IEC 60041 – 1991, "FIELD ACCEPTANCE TESTS TO DETERMINE THE HYDRAULIC PERFORMANCE OF HYDRAULIC TURBINES, STORAGE PUMPS AND PUMP-TURBINES". CLAUSE 14 "THERMODYNAMIC METHOD FOR MEASURING EFFICIENCY" COMMENTS

Harald Hulaas
Norconsult, Norway
Email: harald.Hulaas@Norconsult.no

In this paper we have discussed some topics regarding the thermodynamic method that should be changed in the next revision of the code.

Figure 1 Measuring vessel

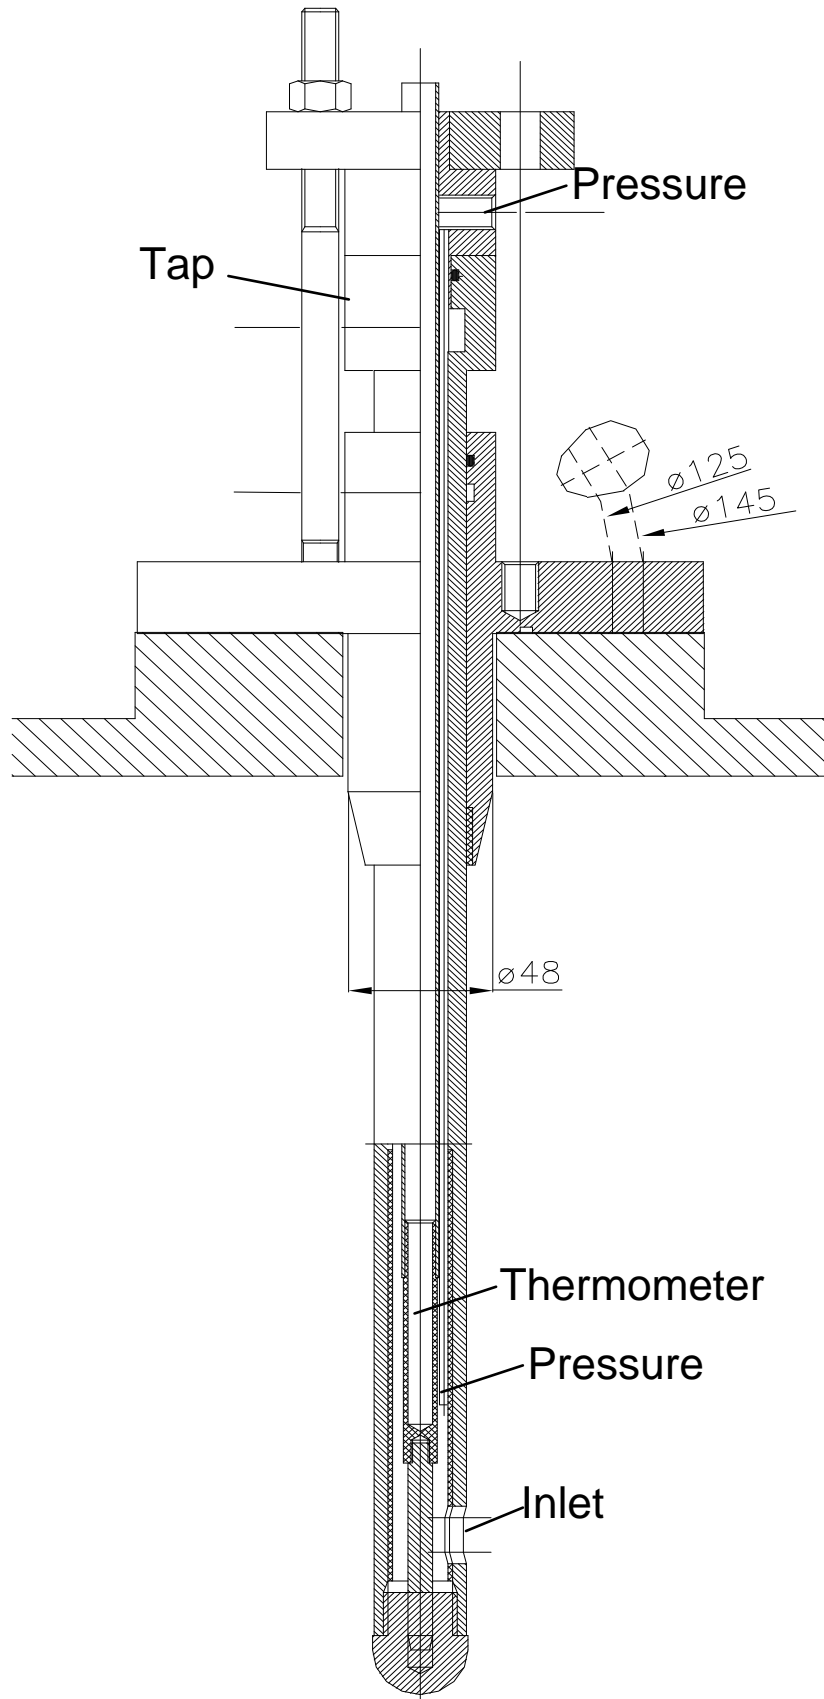
Some vessel designs, see **Figure 1**, have very little, if any, heat exchange with the surroundings, as the thermometer is well inserted into the sampling probe which is surrounded by the main flow.

The pressure at the temperature sensor in the measuring vessels should be measured simultaneously with the temperature, in order to have a correct mechanical energy. This is only possible when the direct operating procedure is applied.

The measuring vessel should be shown to have small values of heat exchange with the surroundings. If the check of heat exchange is required the measuring conditions should be good, else addition errors may be introduced. If the conditions are unfavorable the insulation quality of the vessel can be documented by a record of checks being conducted on that particular vessel.

Figure 2 Horizontal "sampling beam"   **Figure 3 Vertical perforated pipes**

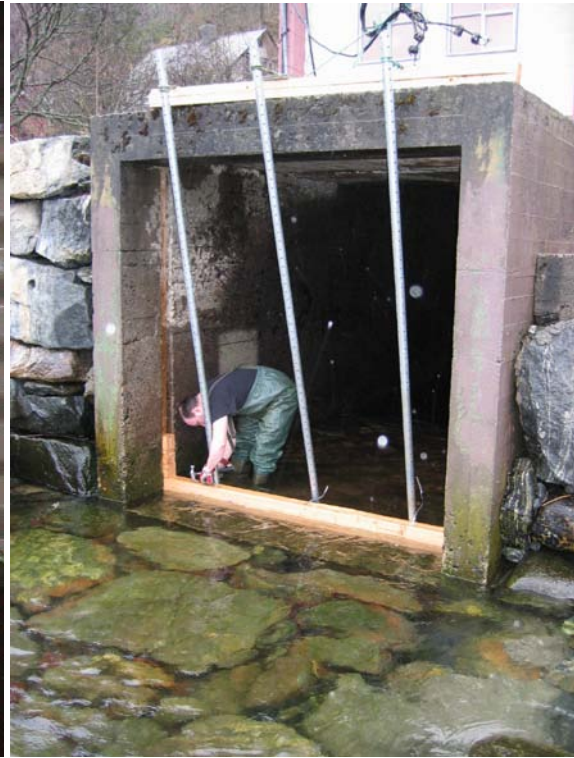
- Another way is to use a central mixing/measuring chamber with temperature sensor and horizontal sampling pipes from 4 or more points distributed over the canal width, and this horizontal "sampling beam" is held in different depths to get the vertical temperature variation. The sampling beam is supported by to vertical steel wires pre-tensioned from the sill to the lintel or bridge above, - see **Figure 2**.

A third method is to have 3 or more vertical perforated pipes from the canal bottom up to a bridge over the tailrace, and one or more temperature sensors can be placed in various elevations in each of the pipes to get the temperature variation over the measuring section, - see **Figure 3**.

It is useful to have the temperature from each measuring / sampling point in the section to be able to carry out a statistical analysis of the deviations, but that is only possible for the third method. With the first method a mixing of all the samples is done in the pipes and the mixing chamber, so no knowledge about deviations between points is available. The second method provides information about the temperature deviation between the vertical positions of the sampling beam, but it is impossible to document how good the "hydraulic averaging" in the beam is at each vertical position.

However, the principle of "pitot sampling" given in the two first cases is very useful, as the amount of water sampled into the pipes are proportional to the water velocity. The measured energy is therefore very close to the average. In ref. [4] it is shown that there is a good agreement between multipoint measurements and sampling frames.

Thus there is little doubt about the "hydraulic averaging" in the pitot sampling arrangement compared to a numeric averaging of multipoint measurements. The code's requirement of at least six points is considered to be met with the pitot sampling arrangement.
